febiEXAKT

Belt tensioner

febi no. 26775

ref. no. 611 200 04 70

febi no. 26775
ref. no. 611 200 04 70

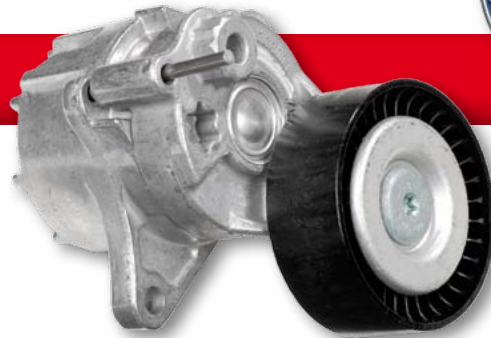
For design reasons, when the vehicle is driven with the original version of the belt tensioner installed (ref. no. 611 200 04 70), noise may occur. (The manufacturer has now replaced this version.)

The noise is generated because the spring is too long and makes direct contact with the base of the housing (1). Only the spring's torsional characteristics are important for this application (2), (6).

The noise is caused when the spring touches the cast-in hollow pin (3) and the base of the housing (4).

febi supplies the belt tensioner febi no. 26775 (ref. no. 646 200 02 70) for the free aftermarket. A highly wear-resistant plastic bushing (5) distance the spring from the base of the housing and prevents metal-to-metal contact where the spring is located. Since only the springs's torsional characteristics are important the height has been reduced (6). The spring makes contact with the plastic bushing (7) and is therefore prevented from touching the base of the housing. No noise can therefore occur. In the new version (8), a steel pin has been cast in the base of the housing in order to center the spring.
